**STATE OF RHODE ISLAND
PUBLIC UTILITIES COMMISSION**

**IN RE: BLOCK ISLAND UTILITY DISTRICT :
TARIFF ADVICE FILING TO ADD :
NET METERING TARIFF :**

DOCKET NO. 5192

**PUBLIC UTILITIES COMMISSION'S
FIRST SET OF DATA REQUESTS DIRECTED TO
BLOCK ISLAND UTILITY DISTRICT (BIUD)
(Issued December 23, 2021)**

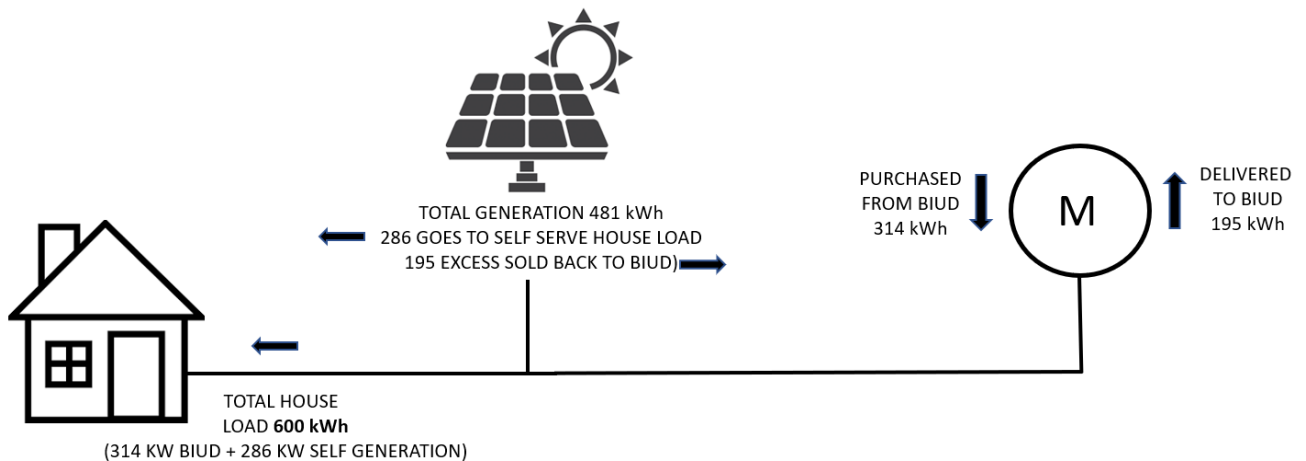
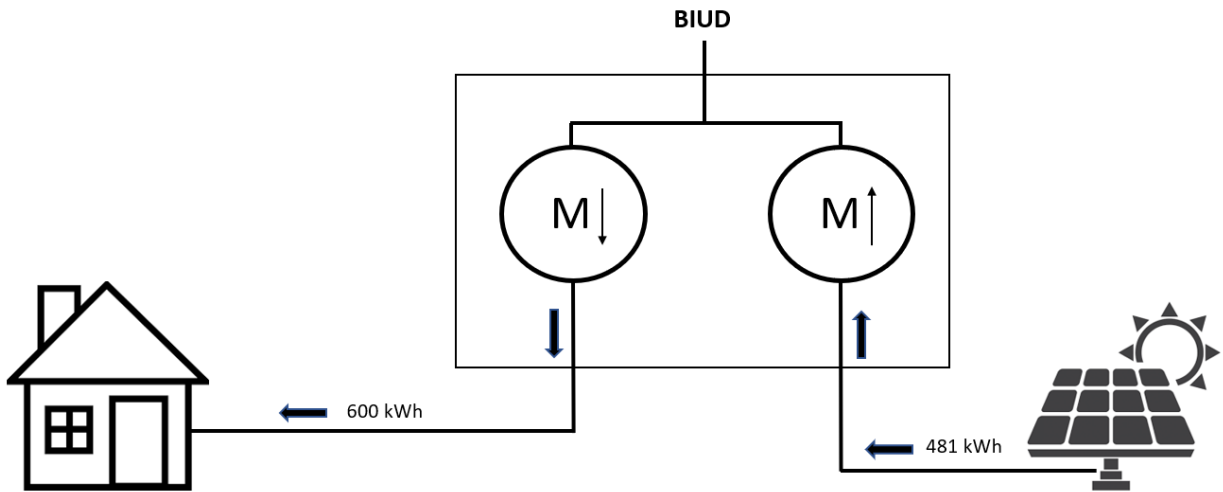
- 1-10. Please explain the difference in the consumption and production data BIUD will gather as a result of requiring two meters in lieu of one meter with two channels. As part of this response, please provide a more detailed explanation of how the two channels function on the single meter (for example, can the utility see usage separately from consumption; can the utility see the time of usage vs. consumption, can the utility only see the net result of the two (the net), etc).

With a single-meter system, BIUD can only measure what electricity flows through the meter. It cannot meter any consumption or generation that does not flow through the meter. Despite having two indexes (Consumed and Delivered) it will not measure solar output that is consumed internally. For example, in the diagram below the home uses 600 kWh during the month. The net metering system served (self-supplied) 286 kWh of the load. BIUD served the remaining 314 kWh which was metered as shown. In addition to self-serving 286 kWh there was 195 kWh of excess generation delivered back to BIUD which is metered as shown and used to offset the member's monthly bill. This demonstrates the "behind the meter" consumption and is an example of how confusing the metering is to the member.

With a two-meter system, BIUD will be able to meter all consumption and all solar output exactly. Using the same example as in the previous illustration, the house load is 600 kWh and the solar output is 481 kWh. In this case, BIUD will bill for 600 kWh of consumption at the retail rate and will then apply 481 kWh of solar credit back towards the bill, netting the two will provide the member's balance due for that month.

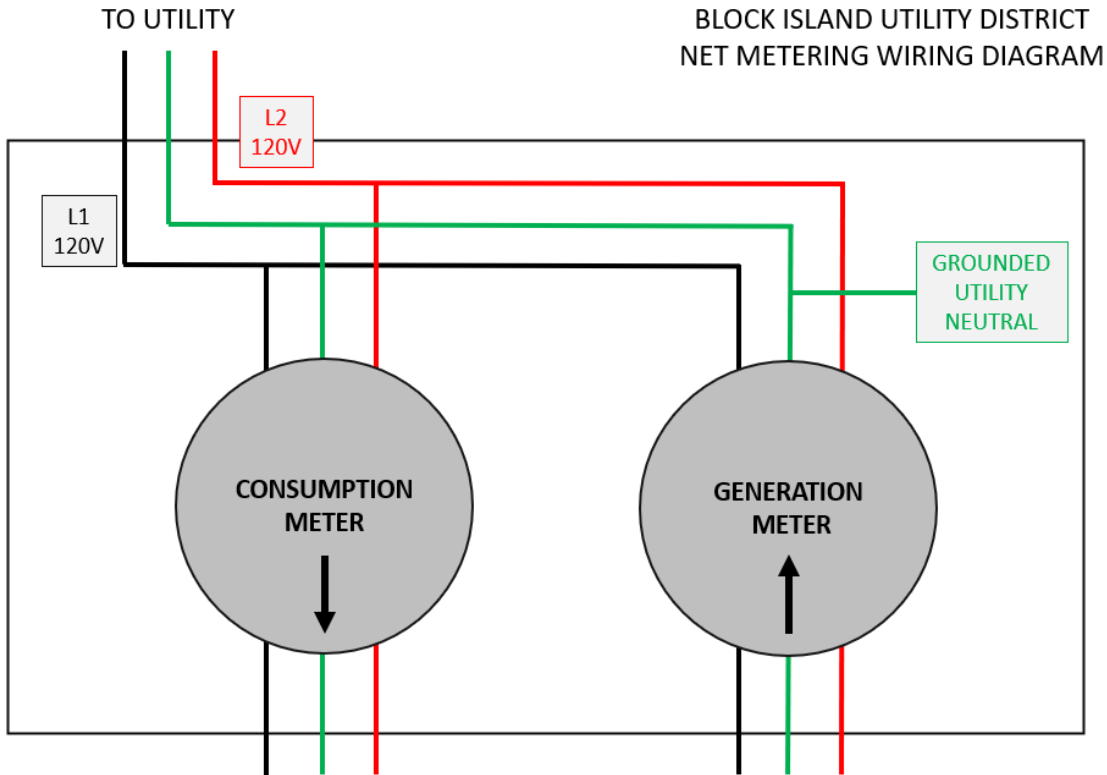
1-12. Will the customer with two meters still be able to use the energy at their home/business to self-supply? If not, how is this proposal net metering?

Yes. The members enrolled in the new double-meter tariff will still be able to self-supply their own load despite it being metered separately. The illustration below shows both meters are housed in the same enclosure which will be owned by the member. The member will also own the service conductors beyond the meter socket to where it attaches to the BIUD facilities located on the pole.

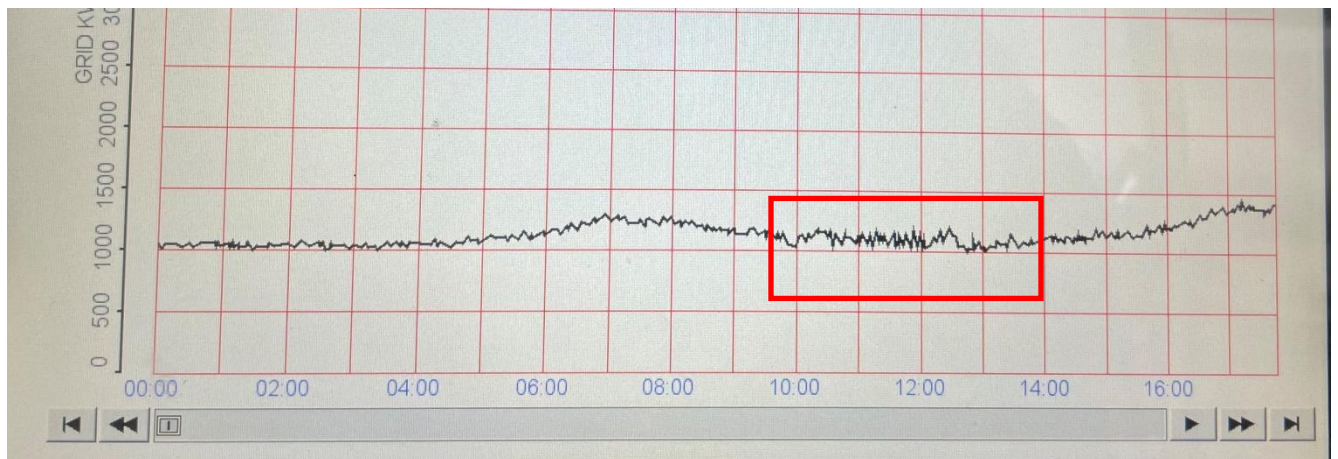
1-14. Is the primary purpose of requiring two meters for system balancing or proper crediting of facilities? Please explain.

The primary purpose of the second meter is to allow BIUD to shut off intermittent renewable generation during times that BIUD is serving its load from the diesel generators. The crude photo below shows the National Grid interconnection flows on a day when there are partly cloudy skies, and the solar output is intermittent.

The photo below is taken from BIUD's control room where real-time National Grid deliveries are monitored. The small variations in deliveries in hours 00:00 through 10:00 is a normal load profile that varies with demand. That load profile is reduced by net metering generation as it increases during the morning hours. Between 10:00 and 11:00, the clouds filled in and the net metering generation became very intermittent. The reaction to this is shown in the dramatic variation in National Grid deliveries. If BIUD had been serving its load from the diesel generators, this would cause system instability as the generator controls would not have had the ability to respond quickly to this variation. The result would have been uncontrollable frequency and most likely would have resulted in generators tripping. At approximately 13:00 the clouds either filled in or cleared out and the deliveries returned to a normal state of variation.
